Notice of Determination

Project Title: Redlands Passenger Rail Project (RPRP)

Following additional coordination with local stakeholders, including the San Bernardino County Flood Control District (Flood Control District) and completion of the Project's 90 percent design, SBCTA is proposing several design refinements to the approved Project. In general, these design refinements are in response to additional hydraulic modeling of the Mission Zanja Channel (MZC) and Santa Ana River (SAR) as part of the approved Project's final design.

Figure 2: Foundation Design at Bridge 3.4 (Vertical)

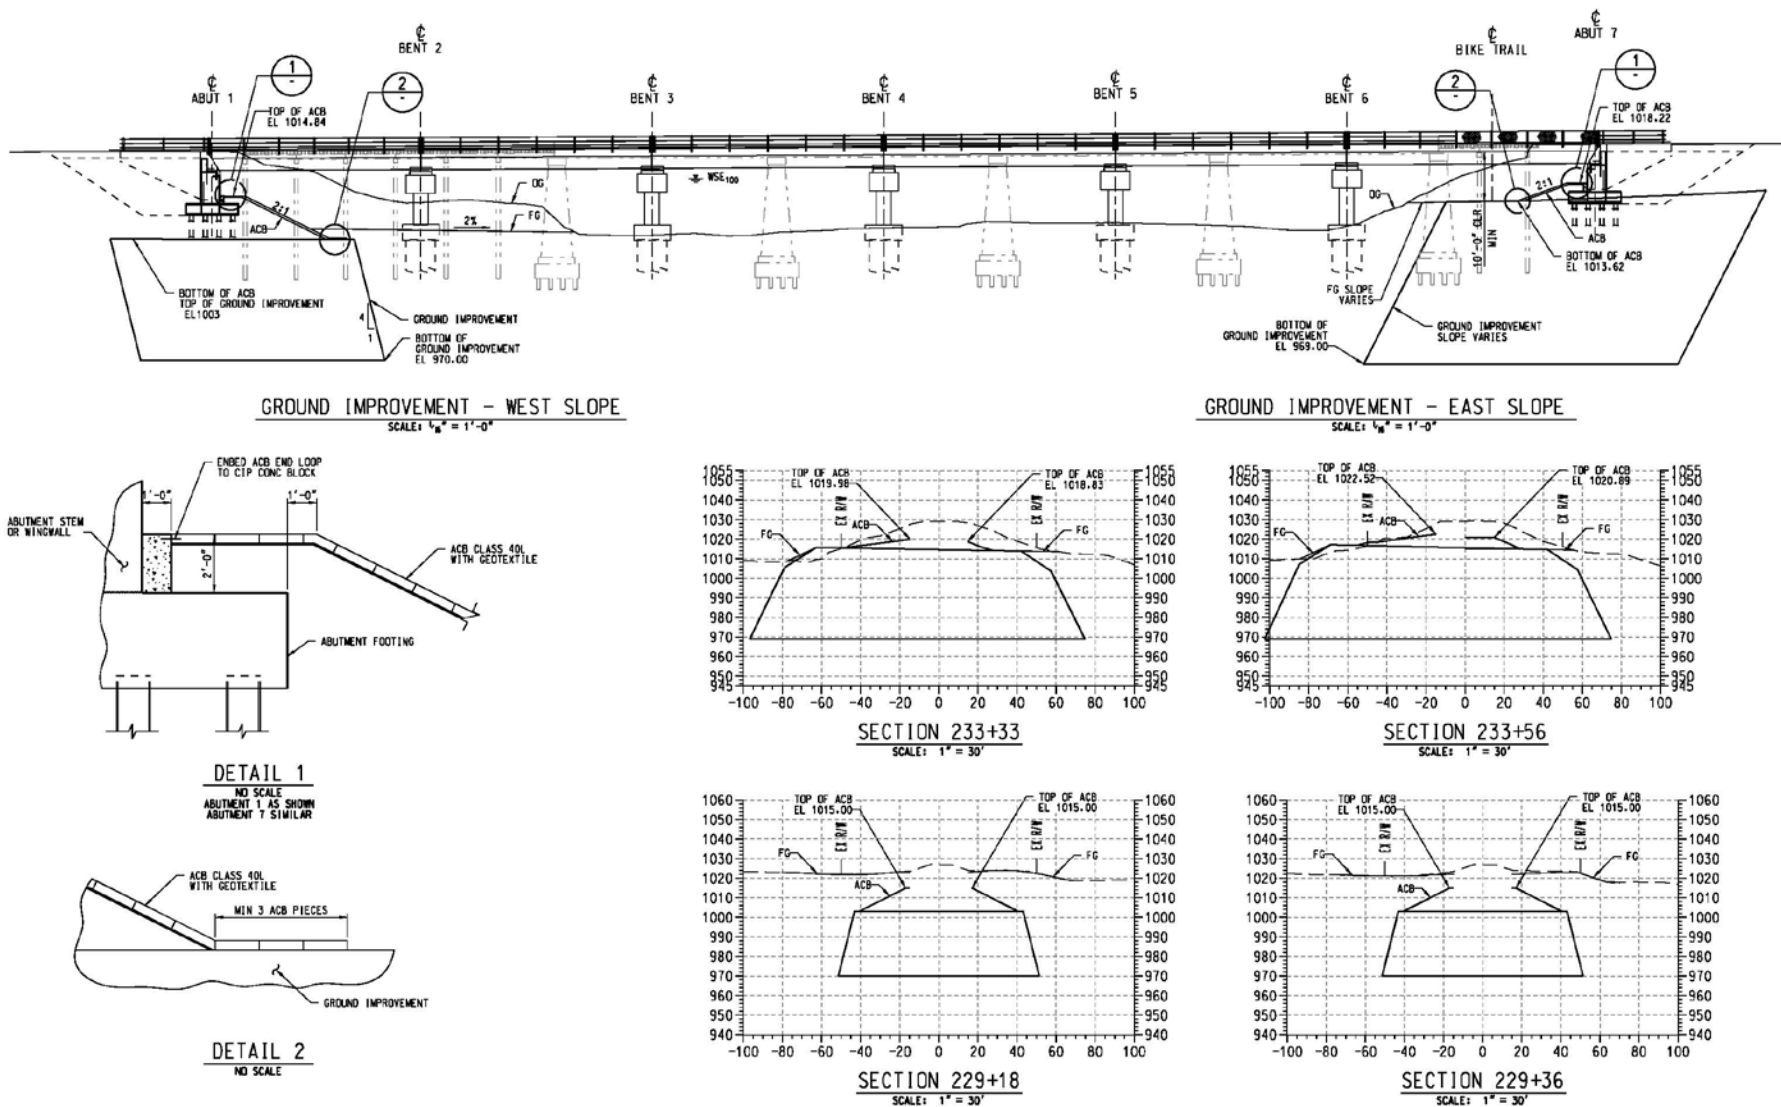
- A. Revised Abutment and Pier Scour Protection: Following additional hydrologic/hydraulic (H&H) modeling and geotechnical investigation as part of the approved Project's final design, SBCTA has identified scour conditions and liquefiable soils at Bridge 3.4 that require the incorporation of revised ground improvement measures for the bridge piers and abutments. The 90 percent design reflects the incorporation of a soil slurry/cement within deeper excavations; capped with articulate concrete block (ACB) (see Figure 2 of Attachment A). These ground improvements would be required at both the west and east bridge abutments and would result in a widening of the channel to 380 feet (previously 365 feet).

Figure 3: Construction Limits at Bridge 3.4 (2015 and 2017 Comparison)

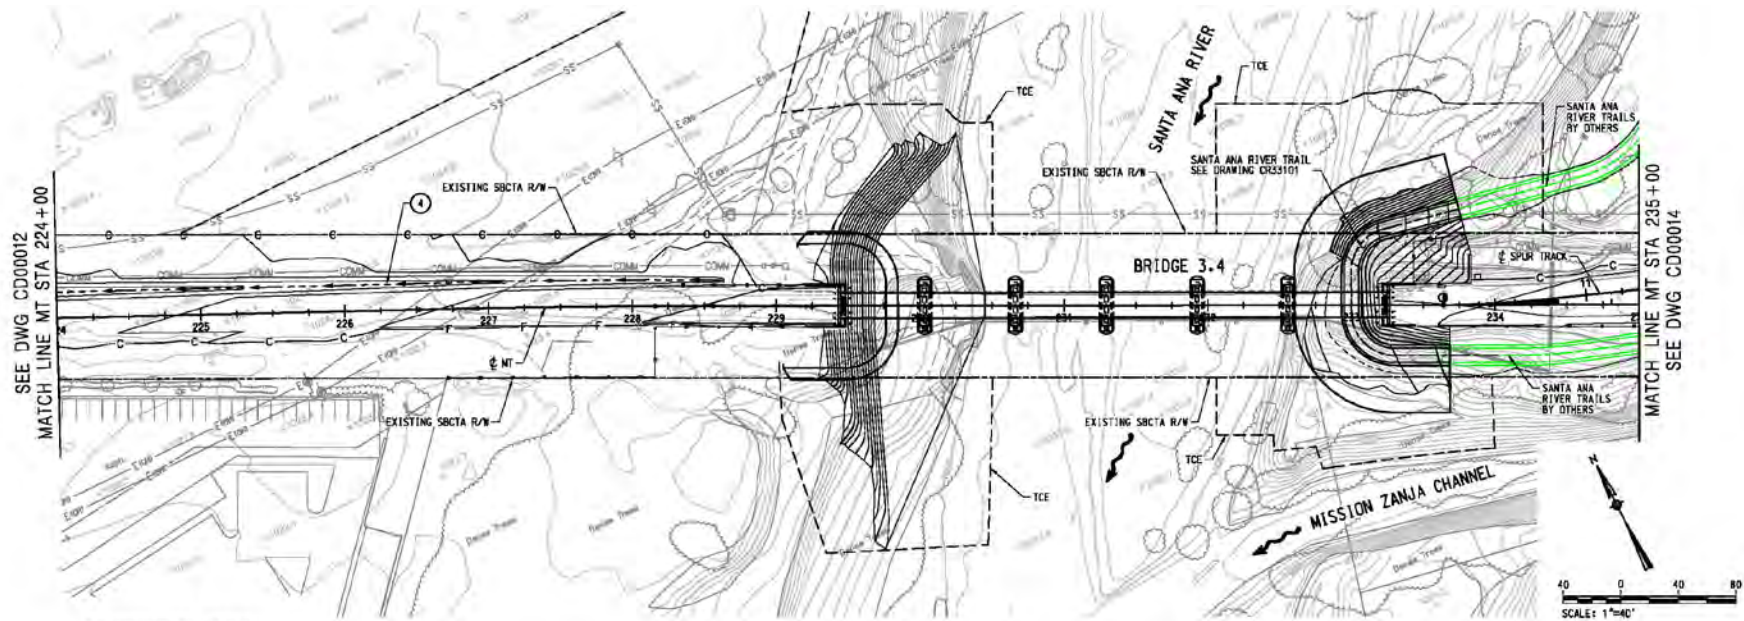
- B. Bank Protection Improvements: Based on additional H&H modeling, additional channel improvements along the western bank are required to address the potential for meandering of the channel to the north of Bridge 3.4. SBCTA is proposing the use of a combination of ACB and vegetated riprap and/or revetment to stabilize the western bank; north and south of the bridge (see Figure 3 of Attachment). The proposed protection would support plant growth and propagation, including the placement of willows (*Salix* spp.) and other native understory plantings. These improvements would extend beyond the previously evaluated physical footprint at Bridge 3.4 (see Figure 3 of Attachment A).

Figure 4: SAR Bike Trail (Proposed Alignment)

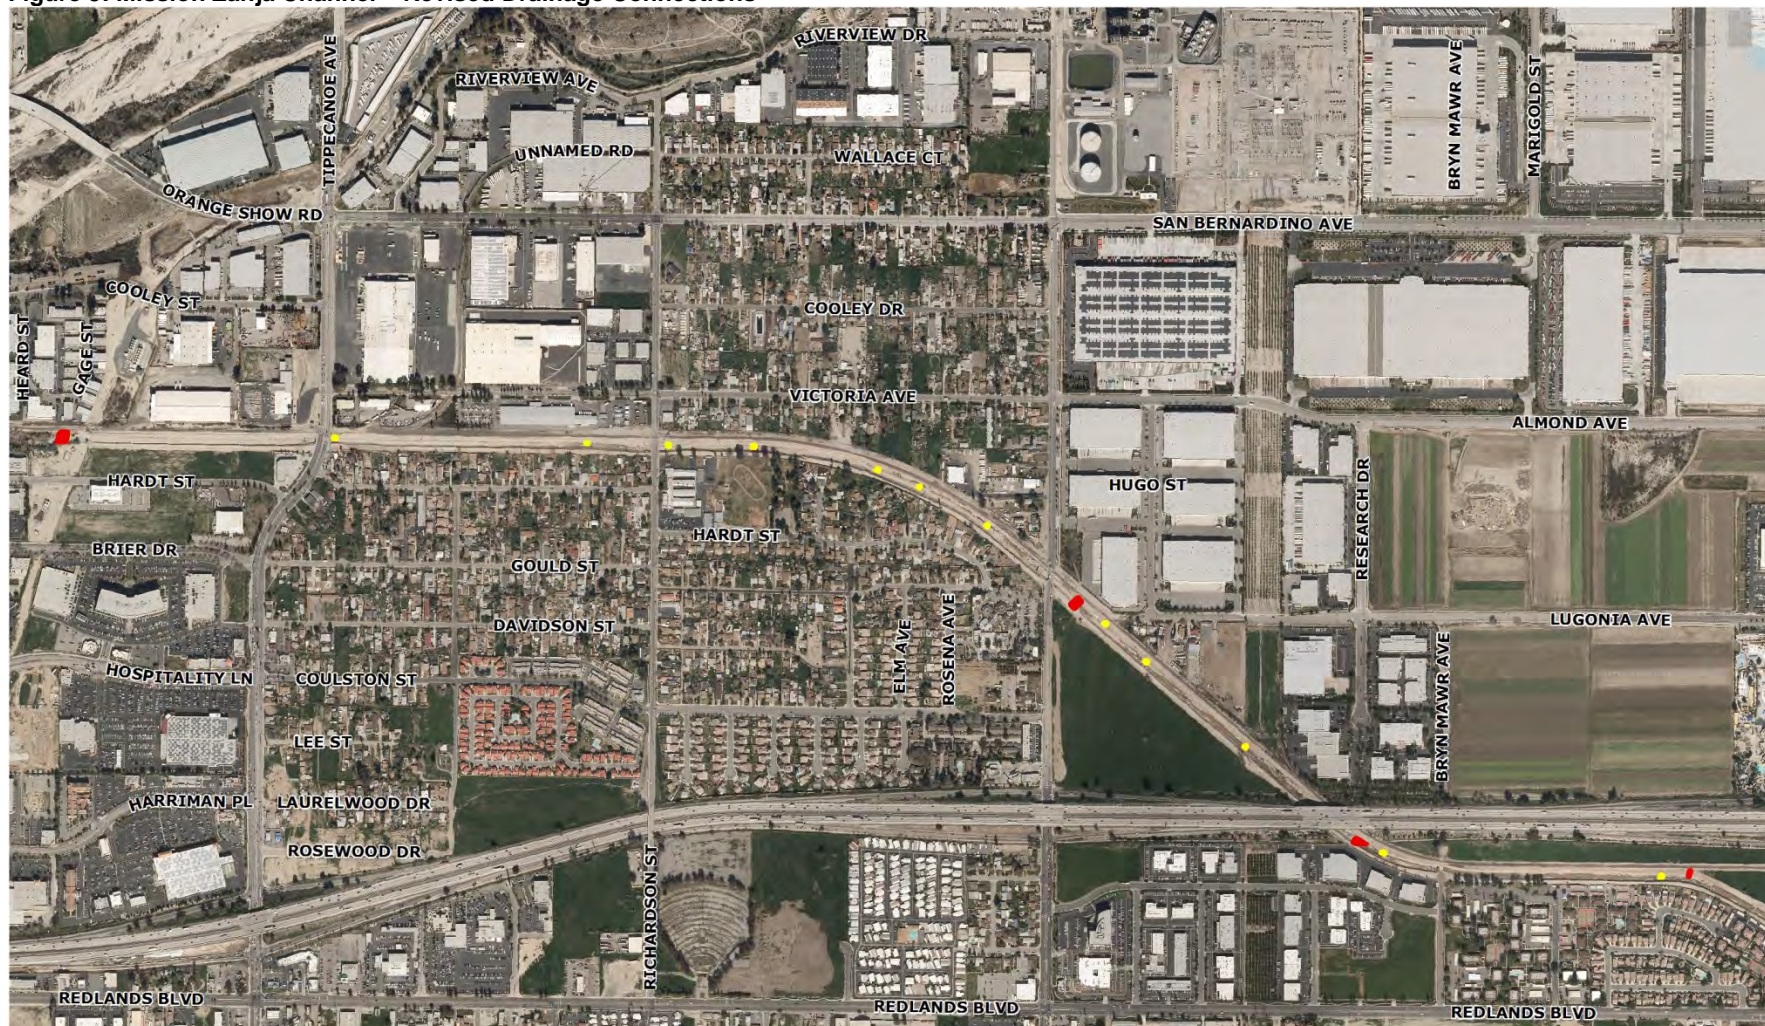
- C. Incorporation of SAR Bike Trail: As required by Mitigation Measure (MM) PCS-1, SBCTA has coordinated with the County Department of Public Works regarding the placement of the SAR Trail across SBCTA's right-of-way (ROW). As proposed in the 90 percent design, the SAR trail would run along the eastern bank and underneath Bridge 3.4 near the seventh abutment (see Figure 4). ACB would be used on the bank above the trail and the trail surface with a protection wall composed of concrete placed below the trail. The County's Department of Public Works will be responsible for constructing the SAR Trail connections to the north and south of SBCTA's ROW.

Figure 6: Replacement of Existing Drainage Connection at Lugonia Avenue

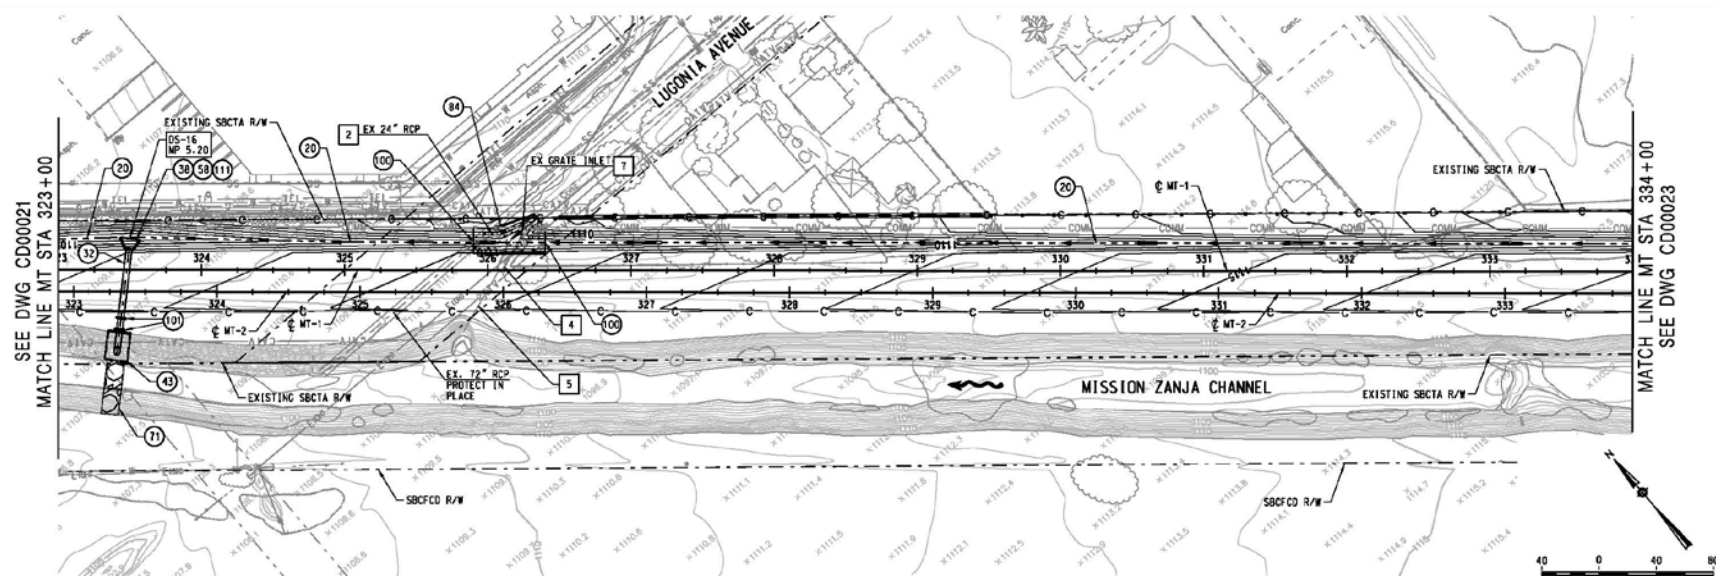
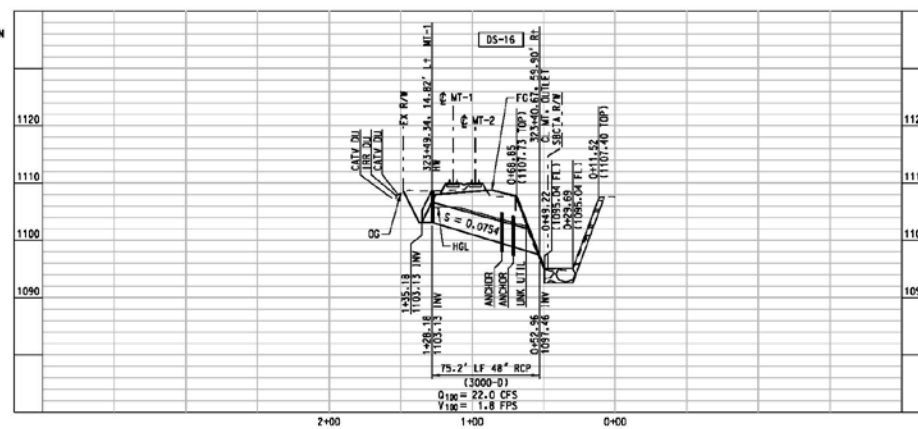
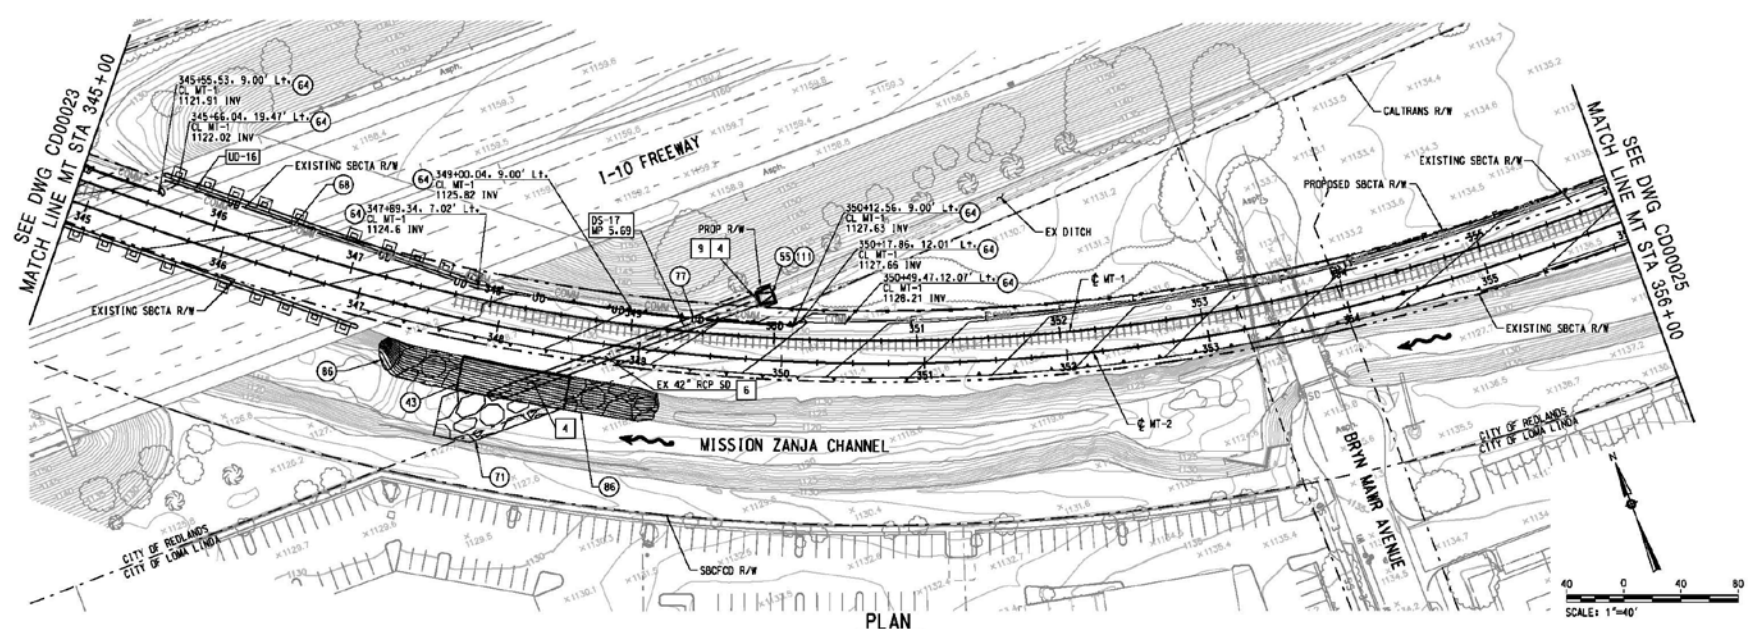
- B. *Replace Three Existing Drainage Connections:* The refined Project would include the replacement of three existing drainage connections along the MZC east of Mountain View Avenue. At Lugonia Avenue, an existing wooden box culvert (deteriorated) would be replaced with a 48-inch RCP with associated outlet protection (see Figure 6 in Attachment A). At I-10, an existing 42-inch RCP would be replaced with a 4-foot by 8-foot reinforced concrete box (RCB) culvert with associated outlet protection (see Figure 7 of Attachment A). East of Bryn Mawr Avenue, an existing 12-inch RCP would be replaced with a 24-inch CMP (see Figure 8 of Attachment A).

Figure 10: New Drainage Connection at Bridge 3.4

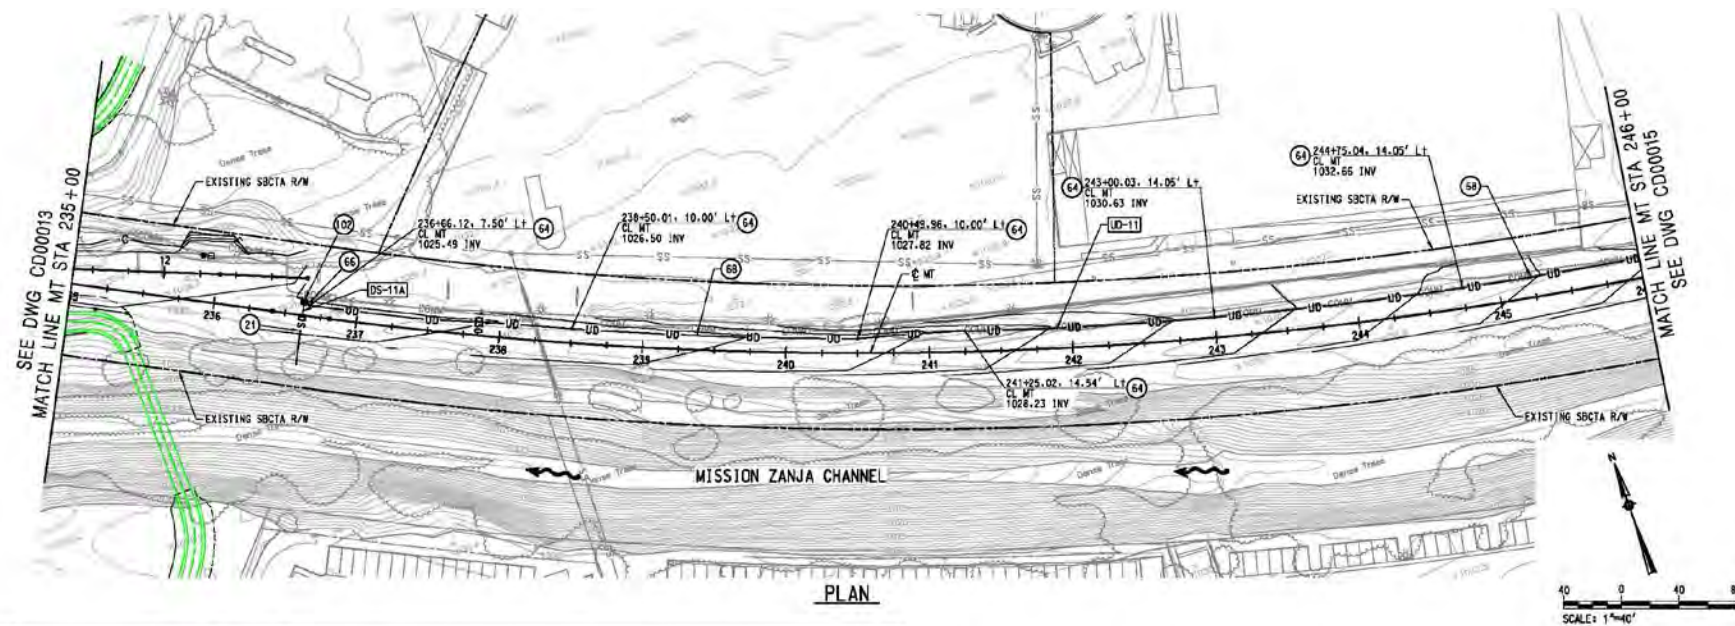
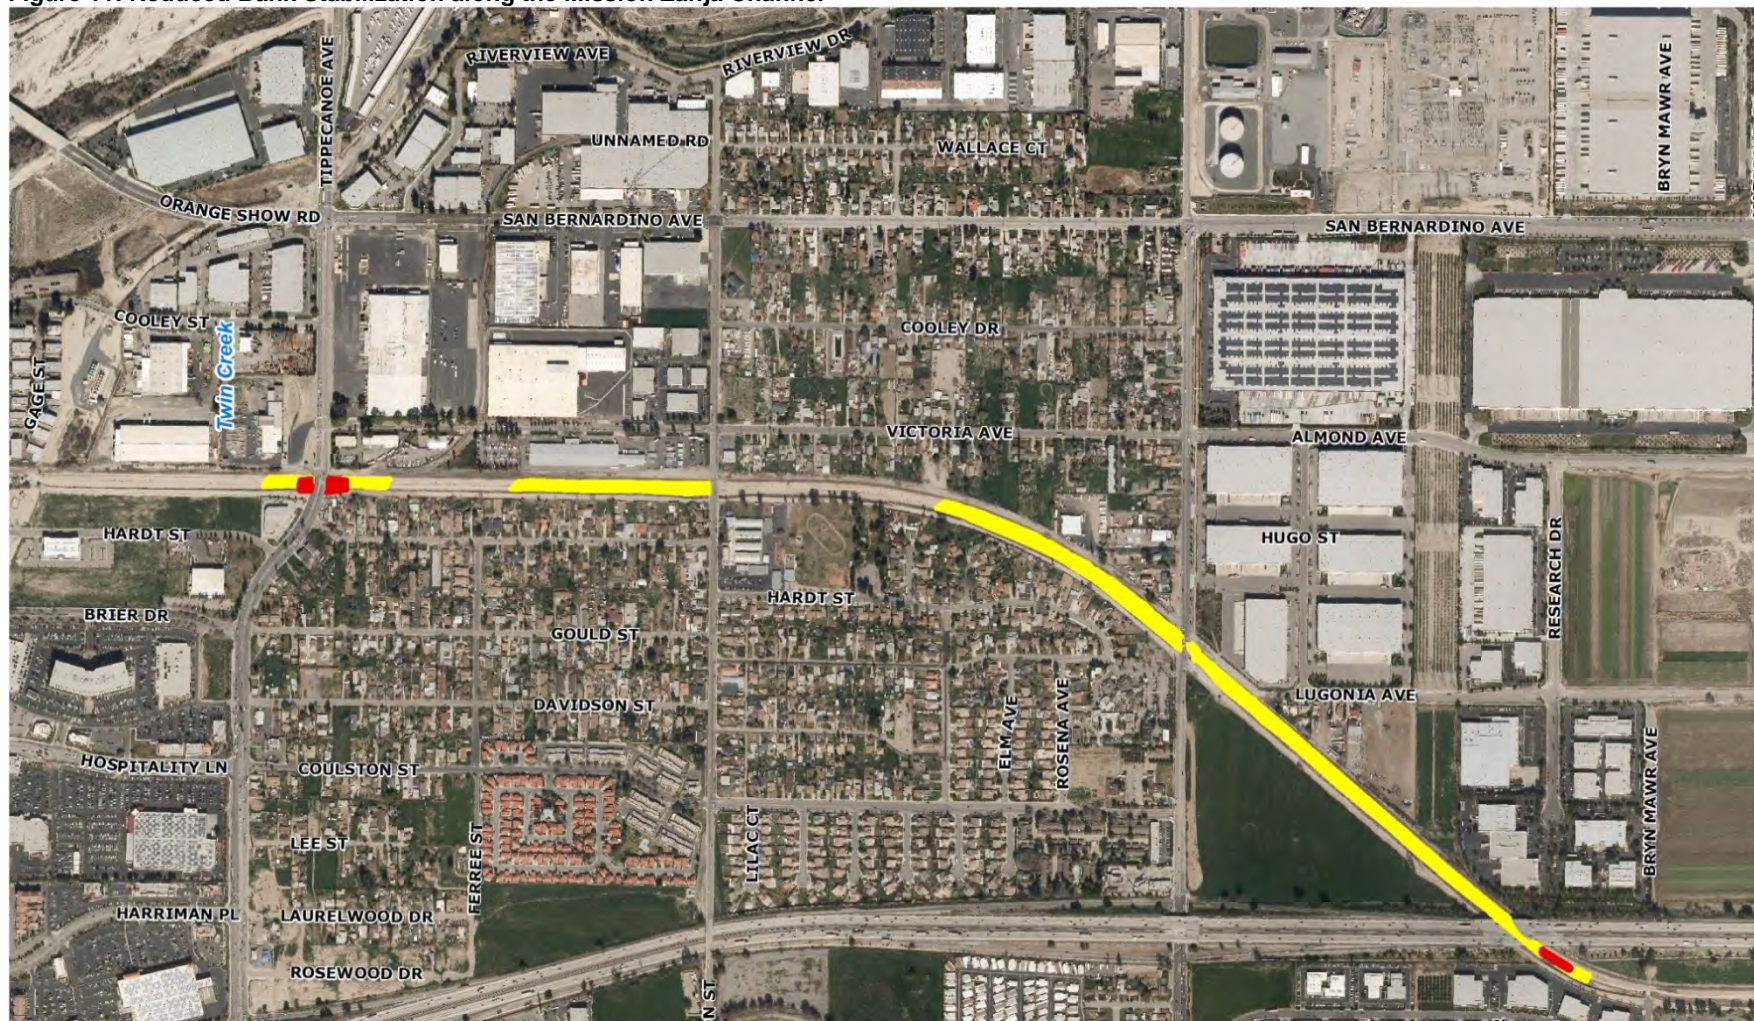
- C. *Construct Three New Drainage Connections West of the Gage Canal:* The approved Project contemplated one new drainage connection west of the Gage Canal (MP 3.8). As part of the refined Project, a total of three new connections would be constructed; one at the confluence with the SAR. The easternmost connection would be constructed just west of the Gage Canal and would consist of a 36-inch diameter reinforced concrete pipe (RCP) with associated outlet protection. Approximately 500 feet west, a second 24-inch corrugated metal pipe (CMP) would be installed. Figure 9 illustrates the current design for these two drainage connections. A third 24-inch CMP would be constructed at Bridge 3.4 (see Figure 10 in Attachment A). These improvements would be constructed within SBCTA’s ROW.
